**W. M. JORDAN COMPANY'S ADDENDUM NO. 1**

**PROJECT: CFCC SA ADDITION**

**DATE: MARCH 17, 2025**

# C-401

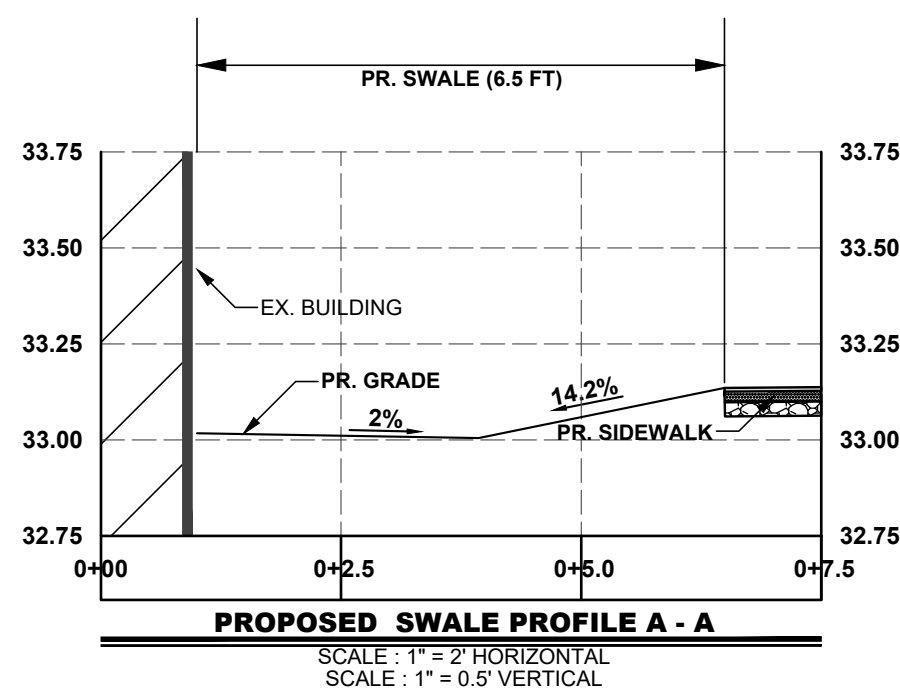
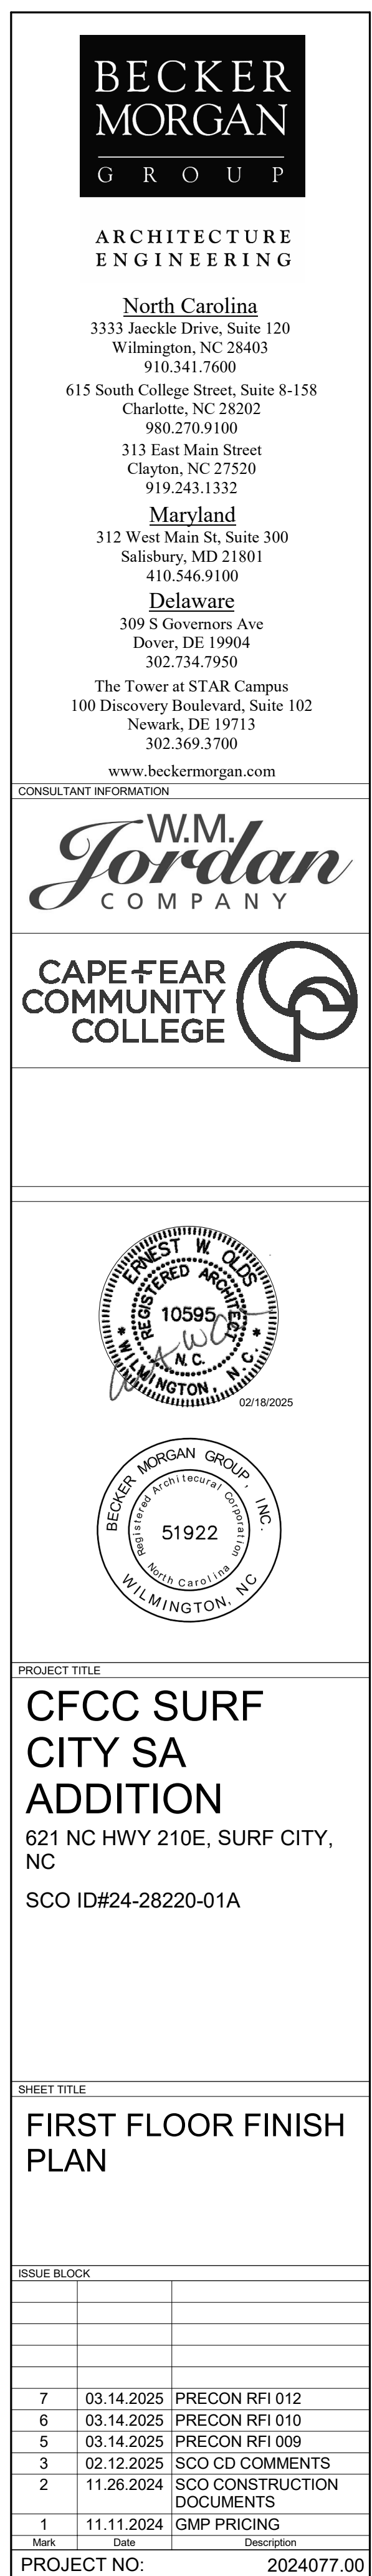
- A. Sheet C-401 Grading Plan.
  - 1. Grades were modified in a few locations. Modifications have been clouded.

**SHEET TITLE**  
ENLARGED PLANS AND ELEVATIONS

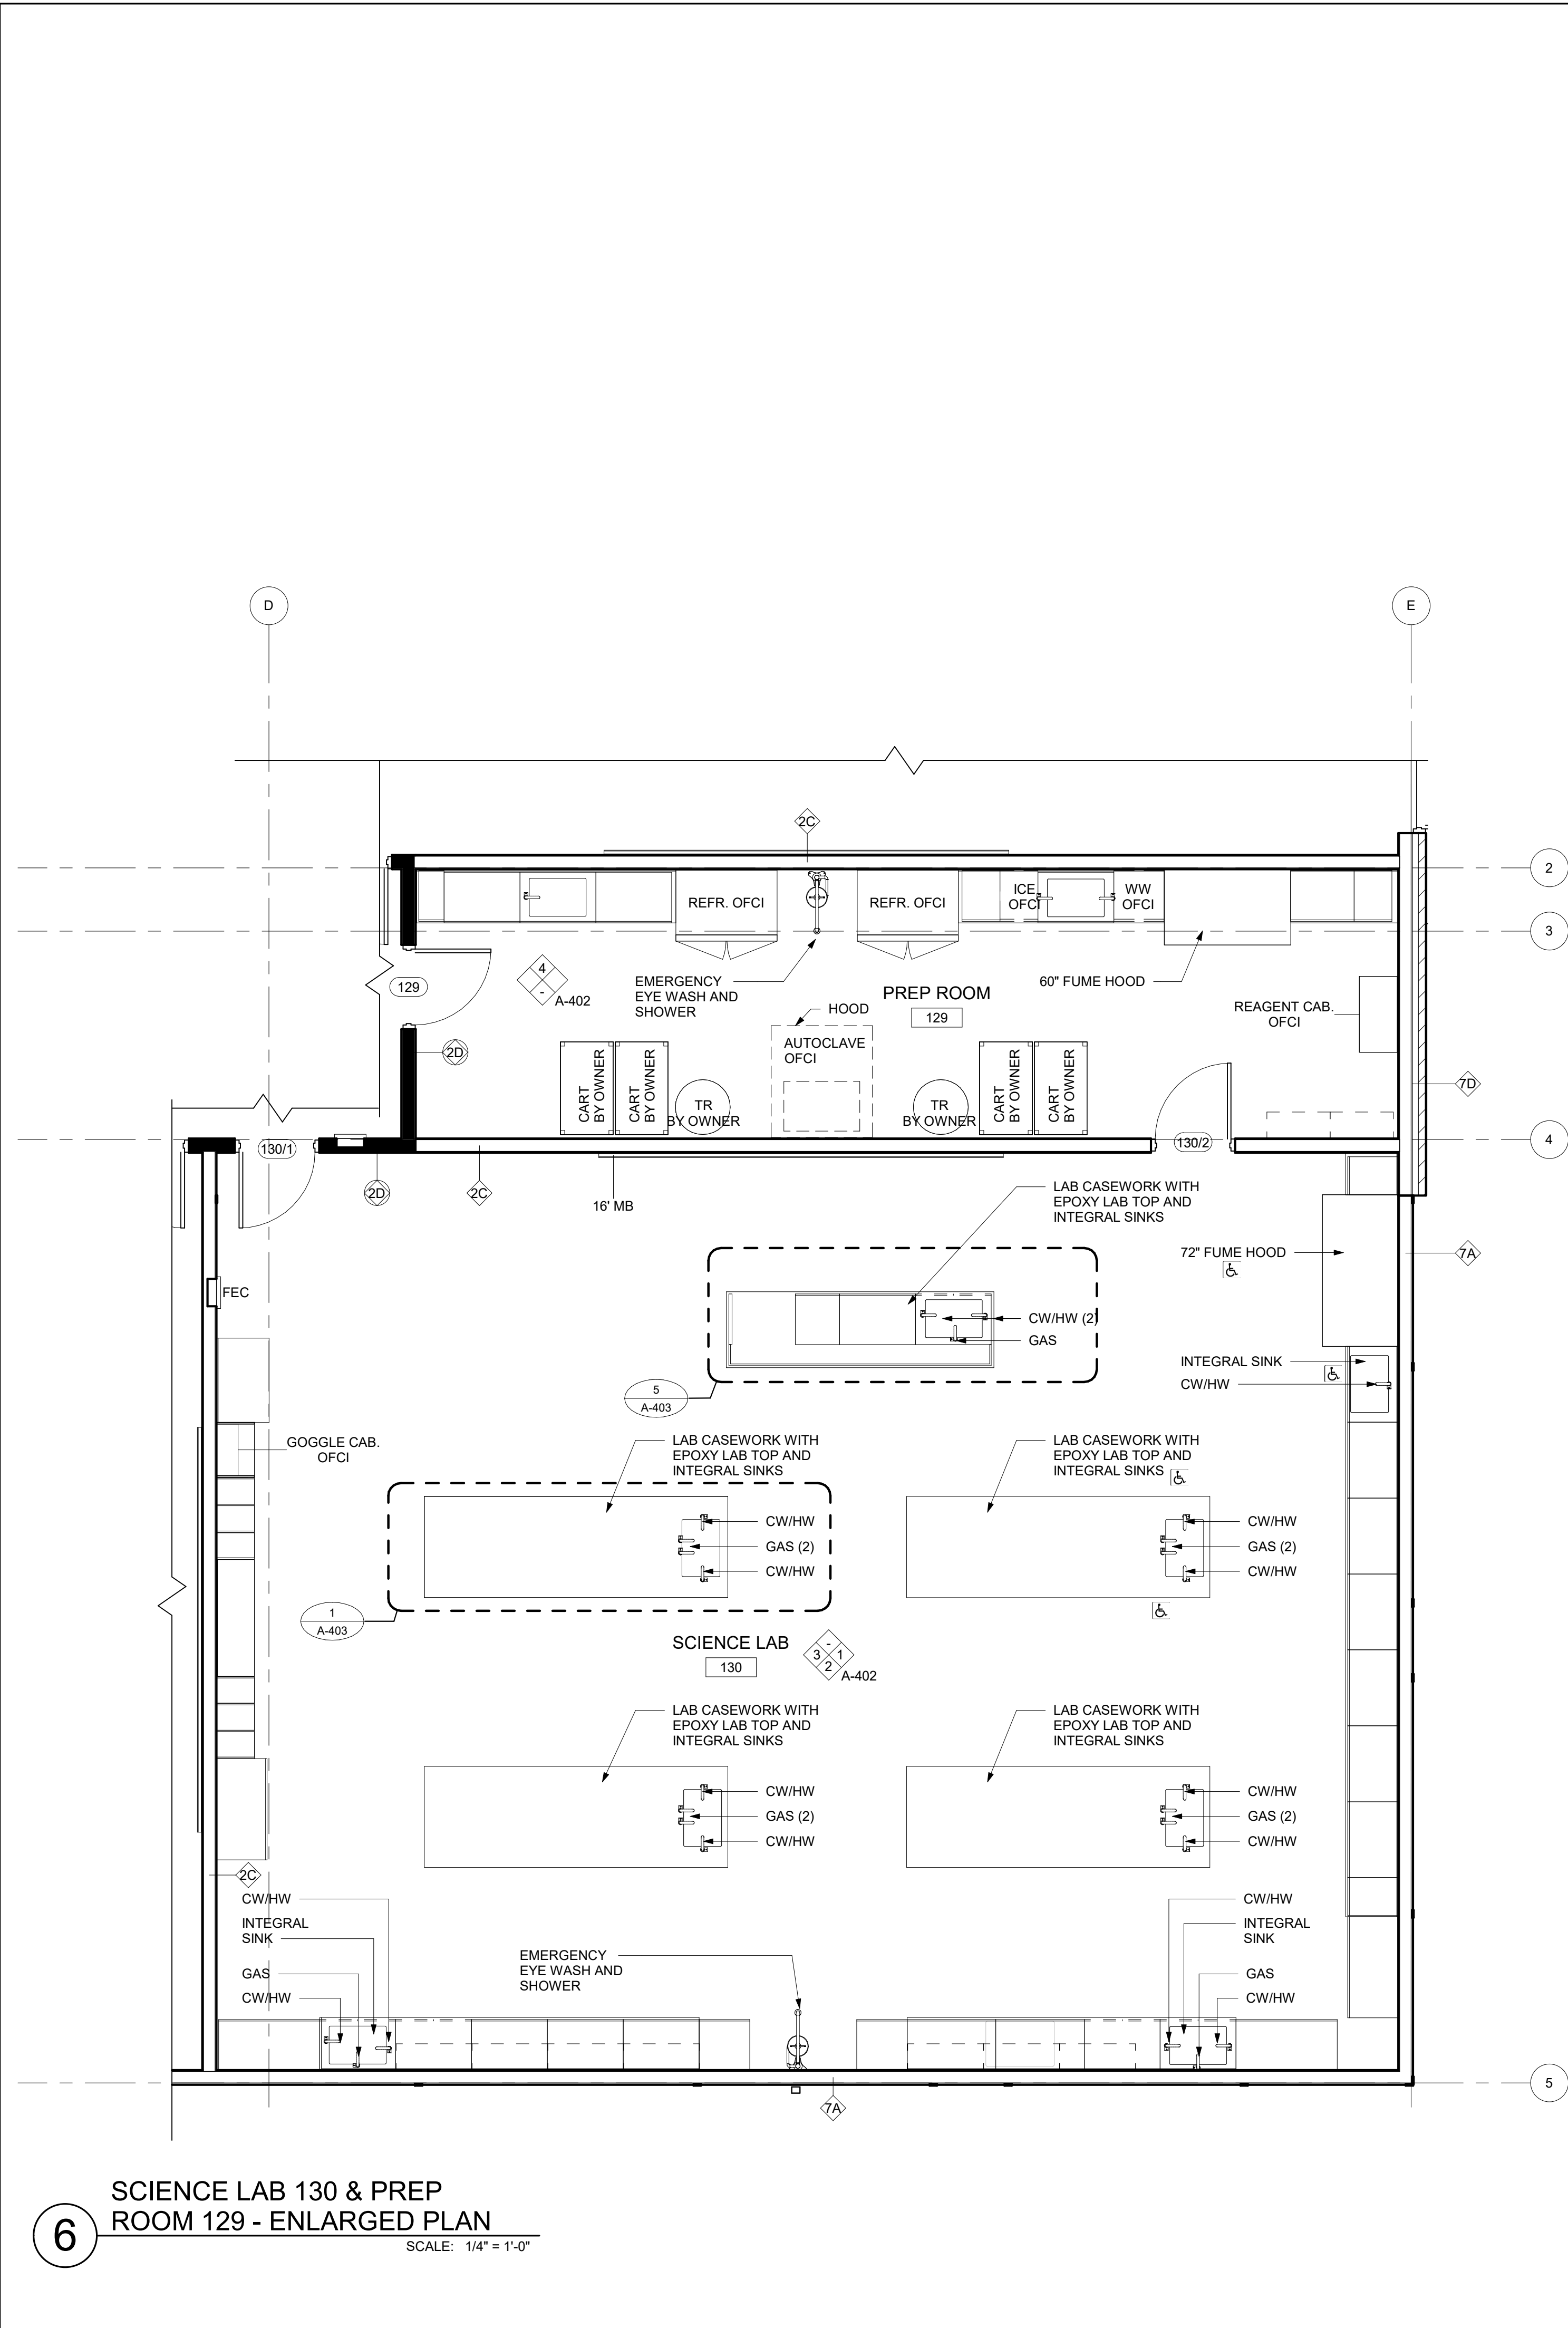
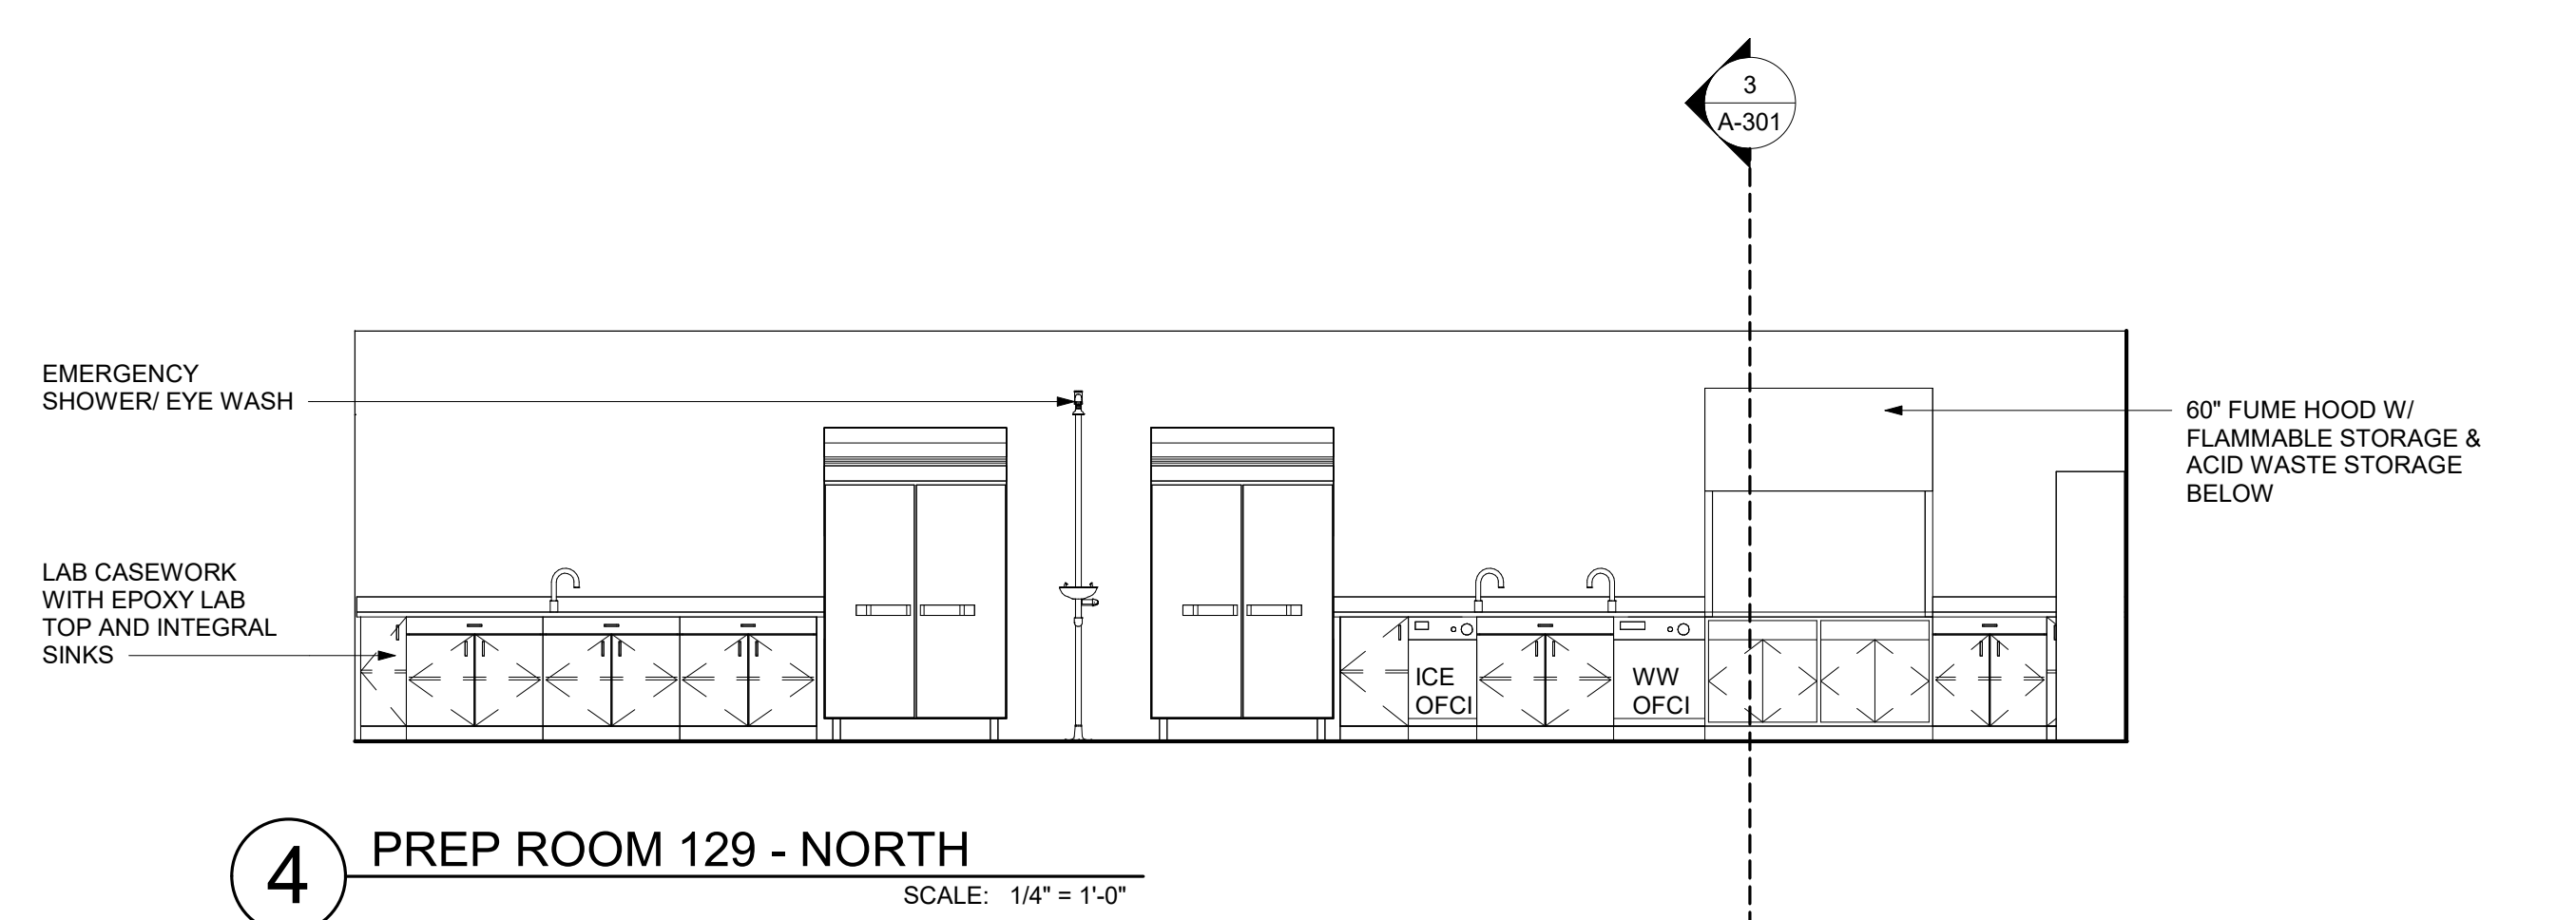
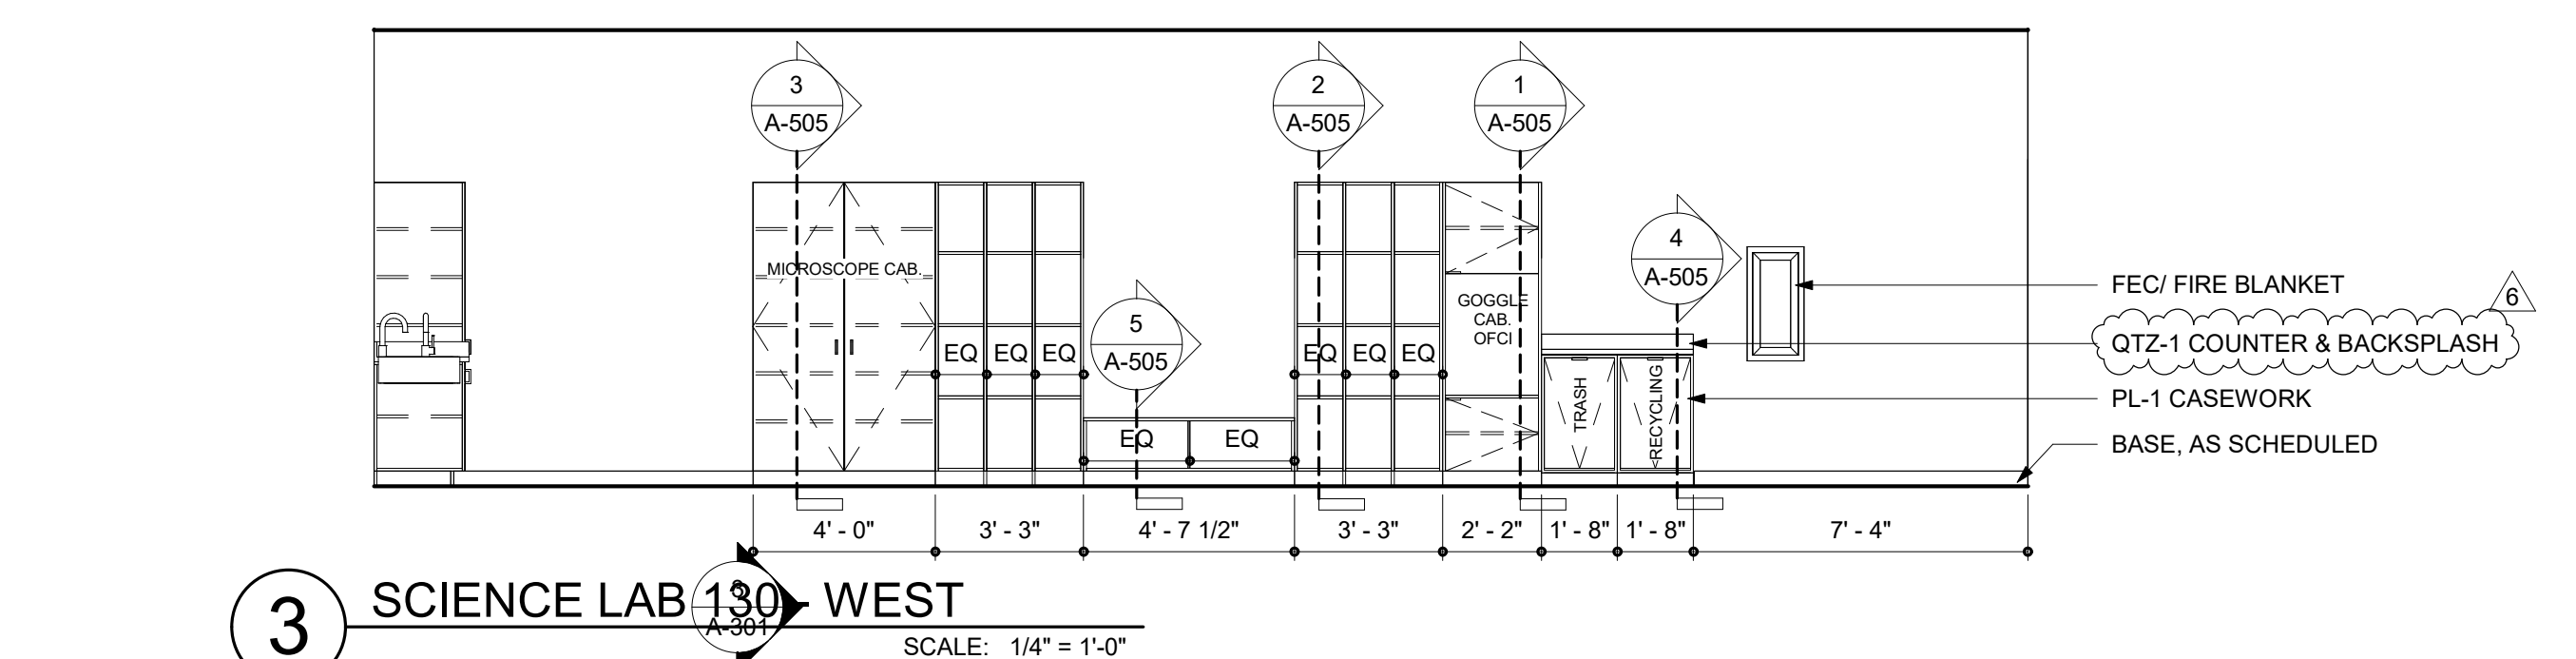
- Answer: Section 123553.19 Wood Laboratory Casework and Section 123552.16 have been added to the bid documents. The intent if for the manufacturer to provide the most cost-effective solution using one of the mentioned scopes. Elevation 3 on A-402 should be included in the base bid. Please provide alternate pricing to furnish and install the most cost-effective solution. Base bid is for plastic laminate, alternate will be for wood. See bid form.

4. *Provide and install one (1) 72" and one (1) 60" Fume Hood with Flammable and Acid Waste Storage Cabinets.*
5. *Provide deduct to not include furnishing and installing plastic laminate casework as shown on detail 3, A-402.*
